Memo

Development Assessment

Record Number:	DA2020/1136
Subject:	Additional submissions to DA2020/1136 - 13 Pacific Road, Palm Beach
Date:	4 May 2021
From:	David Auster Planner
То:	Northern Beaches Local Planning Panel

Figure 1 View from number nine living room rear deck - white height pole to the right of the subject dwelling

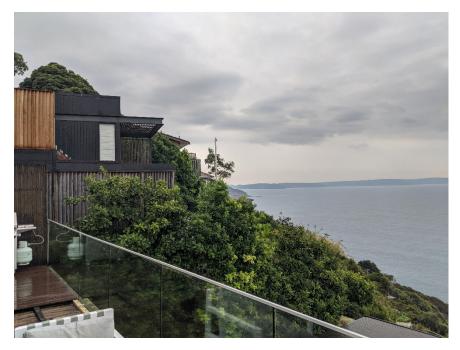
The submission raised concerns with impacts on streetscape, extent of noncompliance with relevant built form controls, and inconsistency with regard to established rear setback created by existing dwellings to the north and south, impacting on views from number 9. Particular concern was raised with the proposed upper level, and rear setback.

These issues have all been assessed within the report, and refusal is recommended based partly on the issues with height, bulk and scale, and view loss. With regard to view loss from number 9, a site inspection has been carried out, and the view loss as a result of the proposal is considered to be negligible in the context of the tenacity principles. The view impacted is obtained across multiple side boundaries, and from the main living area of the dwelling at number 9 the impact will be minimal based on the height poles erected on site (see photos on page below).
